## Memorandum to the City of Markham Committee of Adjustment March 14, 2025

File:	A/006/25
Address:	365 Hood Road, Markham
Agent:	API Development Consultants Inc. (Natalia Garavito)
Hearing Date:	Wednesday, March 19, 2025

The Applicant is requesting relief from the following requirements of the "Employment – Business Park (EMP-BP)" zone under By-law 2024-19, as amended, as it relates to a proposed 15-storey hotel. The variances requested are to permit:

\_\_\_\_\_

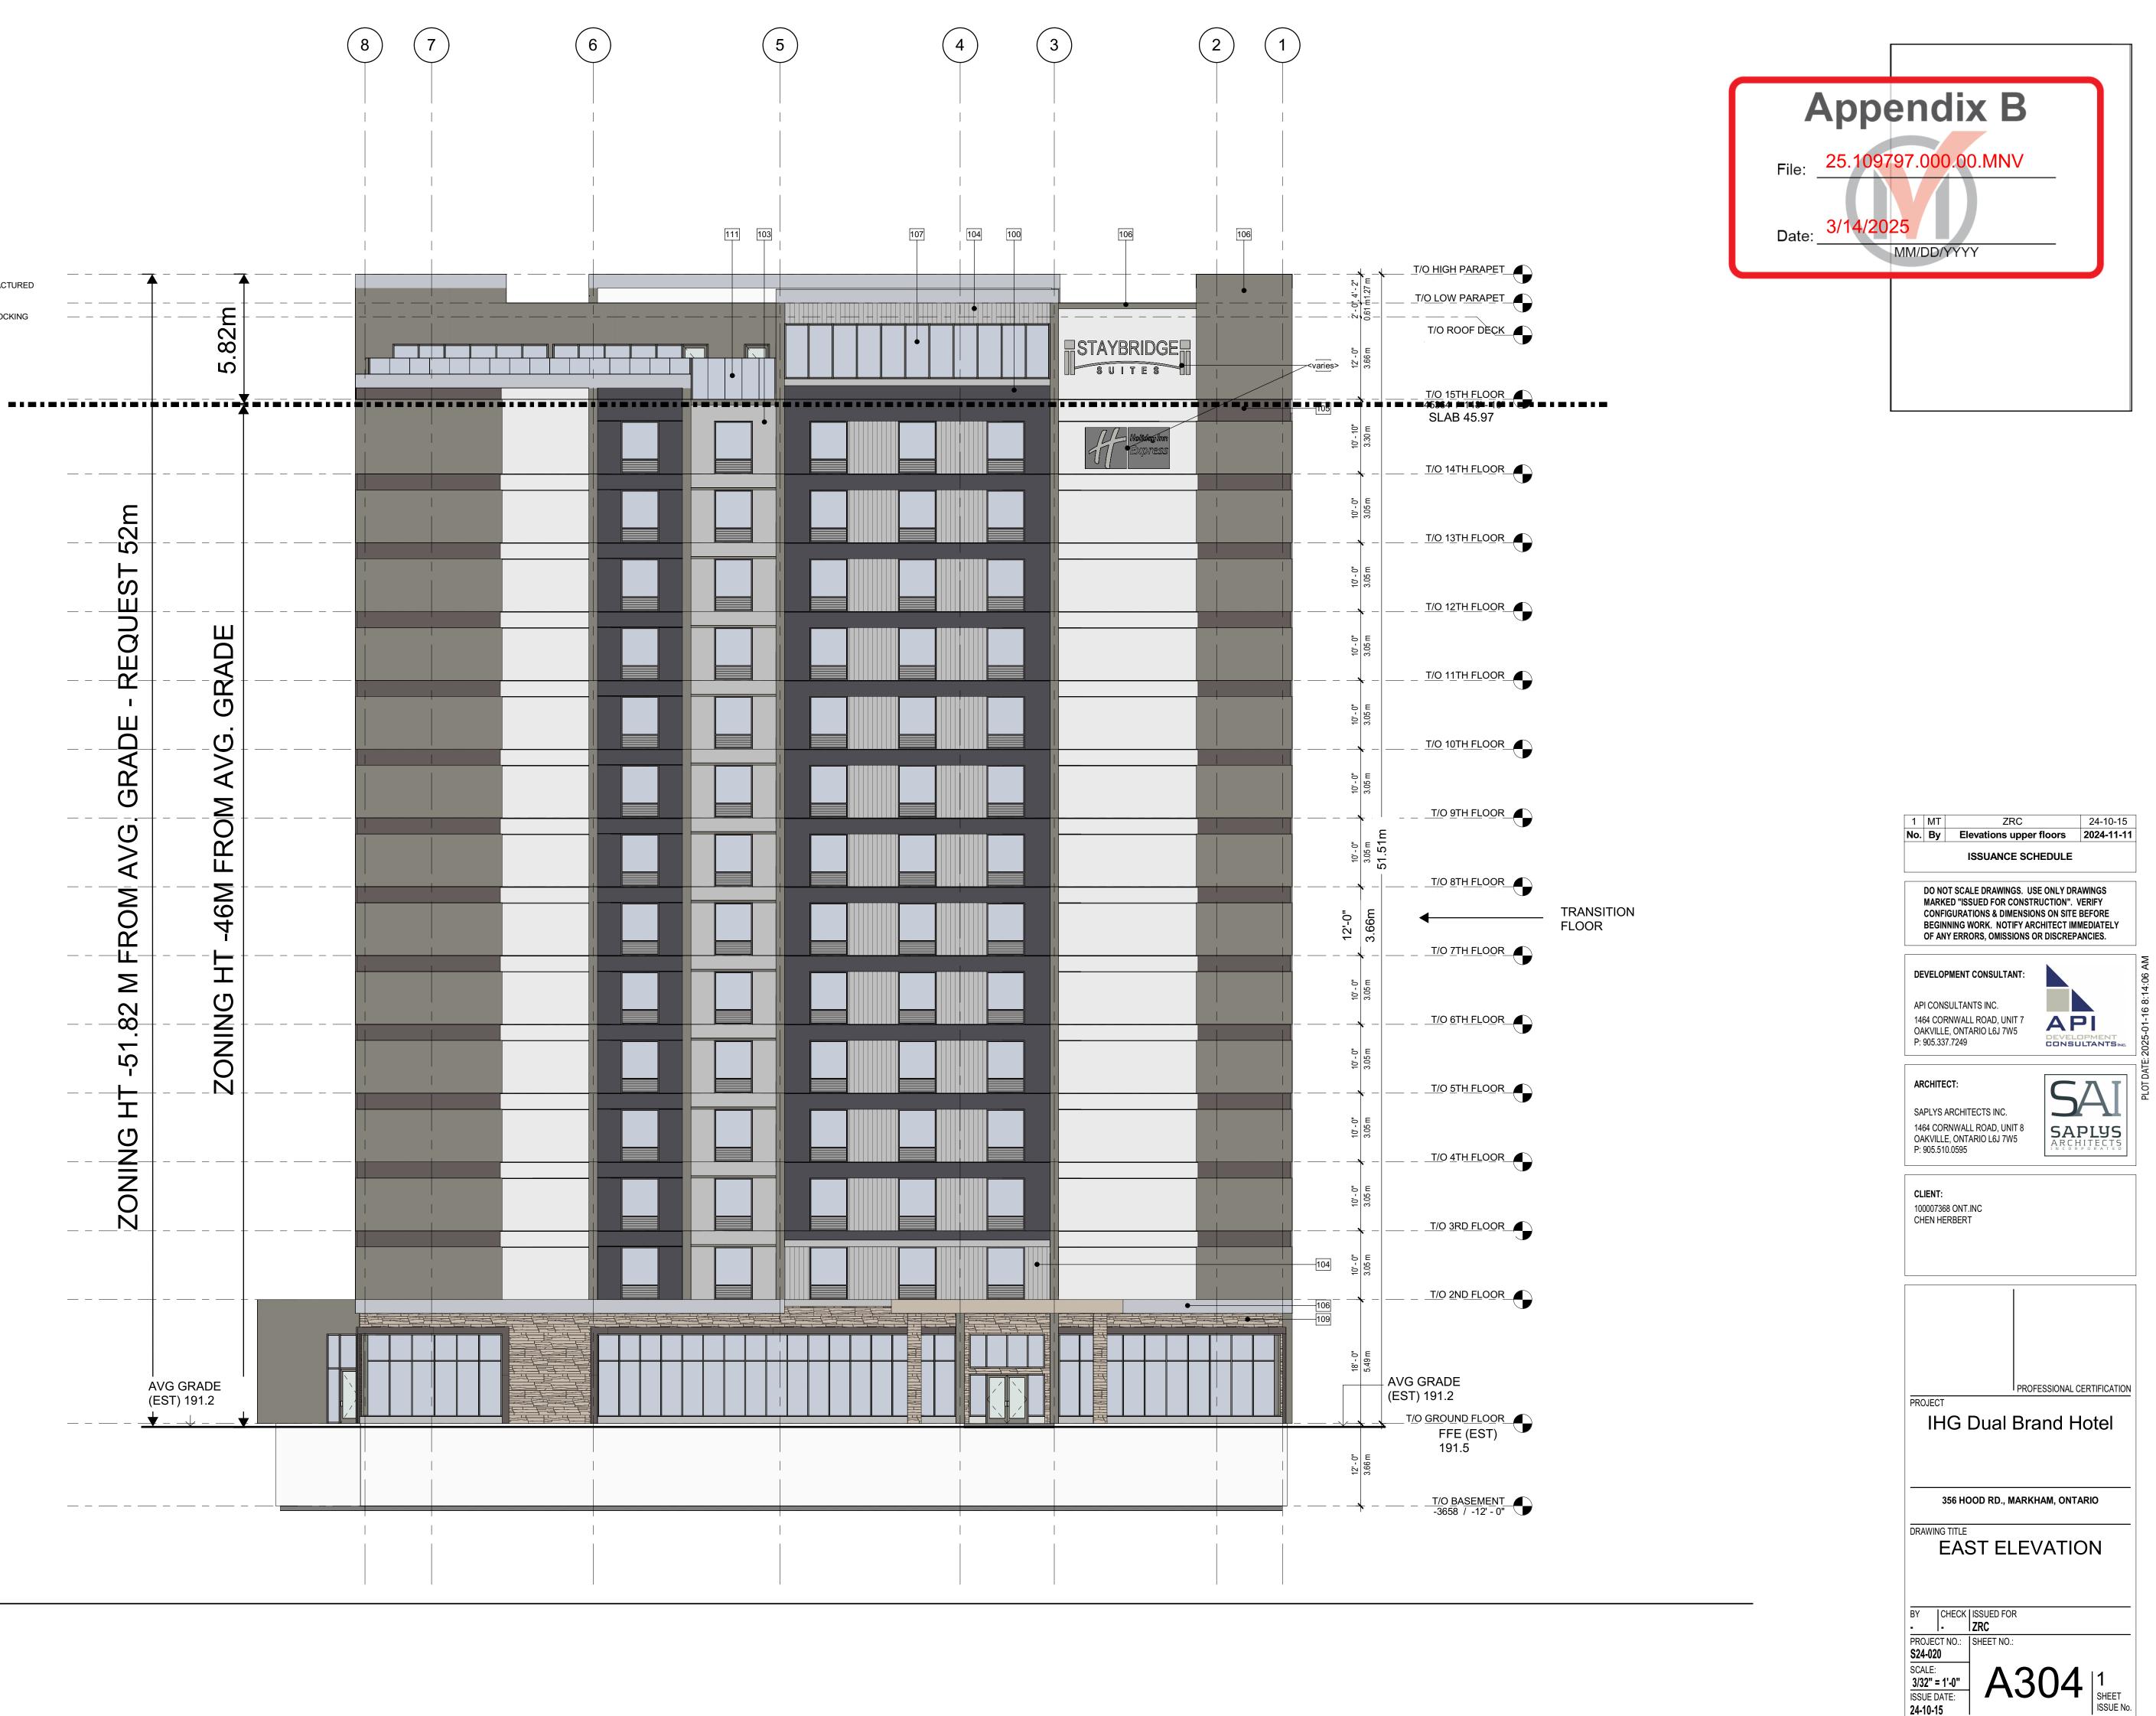
The Applicant is requesting relief to permit a maximum building height of 52 m (170.6 ft) above grade, whereas the By-law permits a maximum building height of 46 m (150.9 ft) above grade. This represents an increase of 6 m (19.7 ft) or 13% greater than the By-law requirement.

The requested variance is to facilitate the 15<sup>th</sup> storey of the proposed development and the rooftop terrace/amenity floor. As existing developments in the immediate surrounding are generally industrial/ commercial office uses, Staff are of the opinion that the proposed height increase will not cause any adverse impacts on neighbouring properties. Therefore, Staff considers the variance sought on the maximum building height to be minor in nature and have no objection.
